SUBJECT: Forwards response to Generic Ltr 87-12 re loss of RHR while
 RCS partially filled.

Subject: Palo Verde Nuclear Generating Station (PVNGS)
Units 1, 2 and 3
Docket Nos.: STN 50-528 (License No. NPF-41)
STN 50-529 (License No. NPF-51)
STN 50-530 (License No. NPF-65)
Response to Generic Letter 87-12
File: 87-A-056-026

RESPONSE TO NRC REQUEST FOR INFORMATION
ON LOSS OF RESIDUAL HEAT REMOVAL

Figure 1
Permanent Level
Indication System

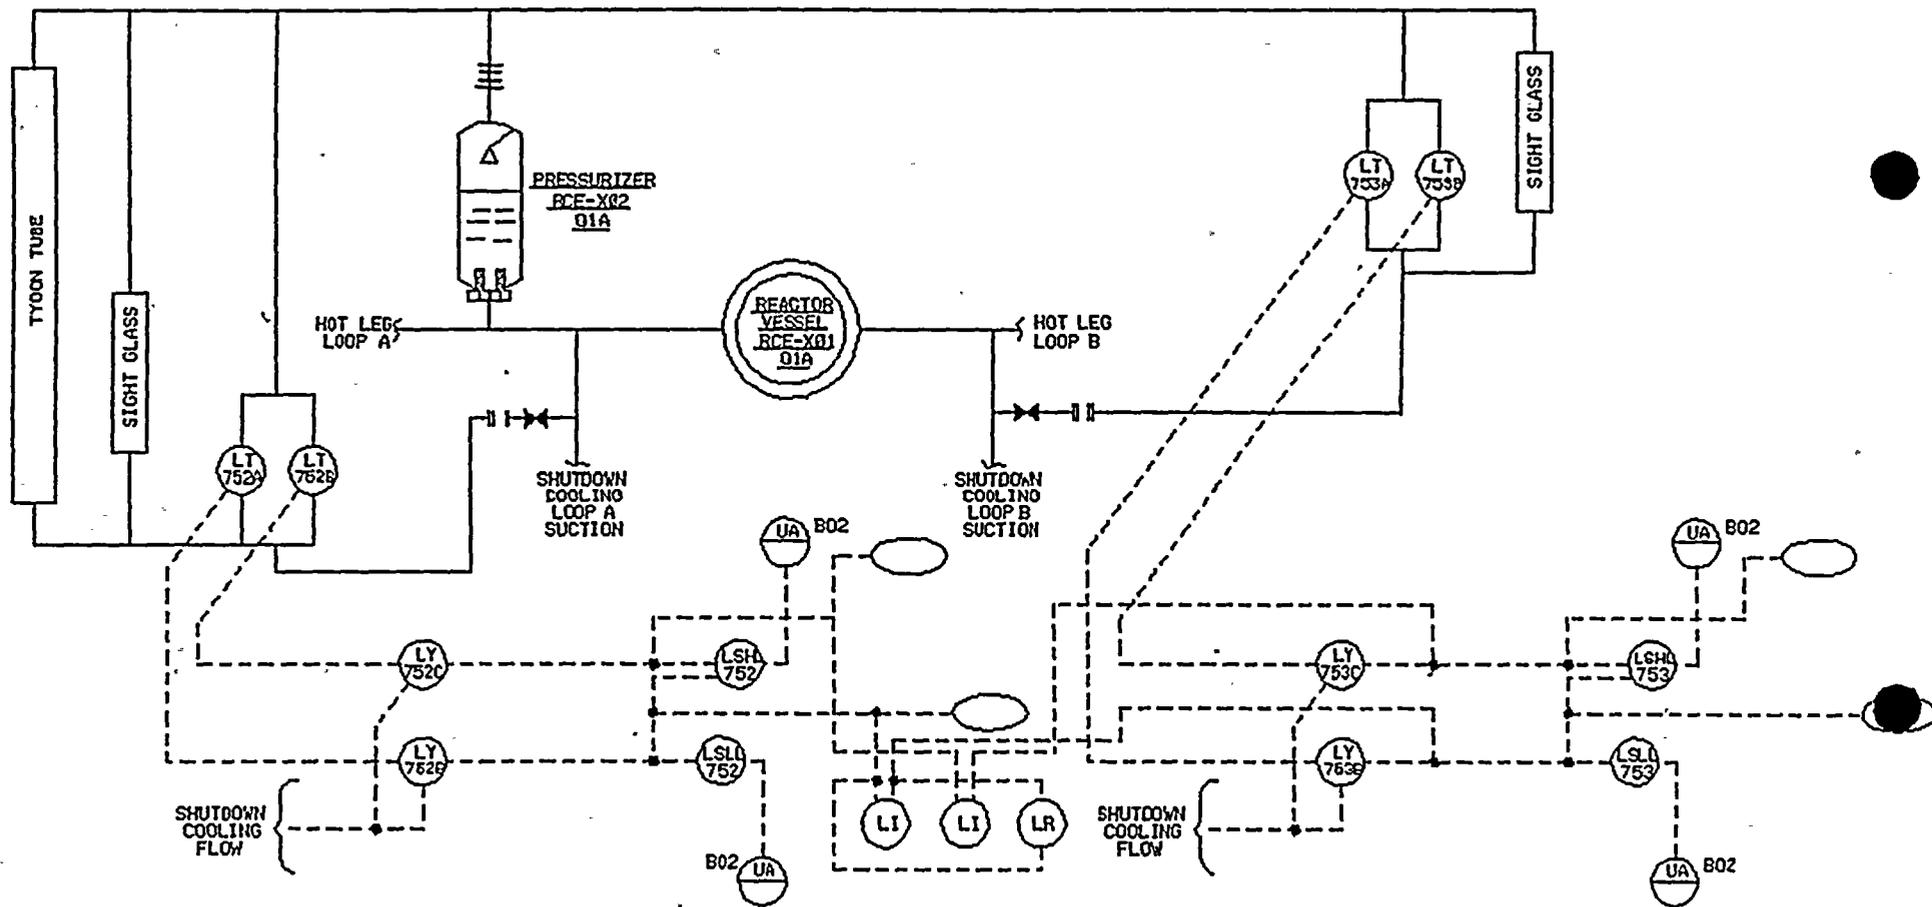
(3) NRC QUESTION

Although this tygon tube level indication system will be used during each units next refueling outage (and until such time as the new system is installed), ANPP is also initiating a modification to install a dedicated refueling level instrumentation system in each unit. The proposed system consists of control room level indicators receiving signals from the level transmitters (one wide range, one narrow range) on each hot leg. The level signals are sent to the main control room for display on two level indicators and one level recorder. The signals are also input to the plant computer for trending and to the plant annunciator system for main control room alarm output. The current plans are to provide the main control room with a high level alarm, a low level alarm and a low-low level alarm. Since the redundant systems tap off of the shutdown cooling suction lines, compensation is provided to correct the level signals during operation of the associated SDCS loop. This compensation is accomplished by characterizing the flow signals from the SIA-FT-306 and SIB-FT-307 transmitter loops and summing to the new level indication loop. Although final design work is still in progress, the new refueling level indication system is expected to resemble Figure 1.

- (1) Implementation of the design change to install a permanent refueling level indication system in each of the PVNGS units. As discussed in the response to question 2, it is expected that this system will consist of separate level indication from each of the RCS hot legs with compensation for SDCS flow and indications and alarms in the main control room. Final engineering work on the design is still in process with a projected completion date for the design of June 30, 1988. Based upon completion of the design work by this time, it is expected that the permanent refueling level indication system will be installed during the second refueling outages for Units 1 and 2. Additionally, installation of the modification in Unit 3 is expected to be completed during the first refueling outage.
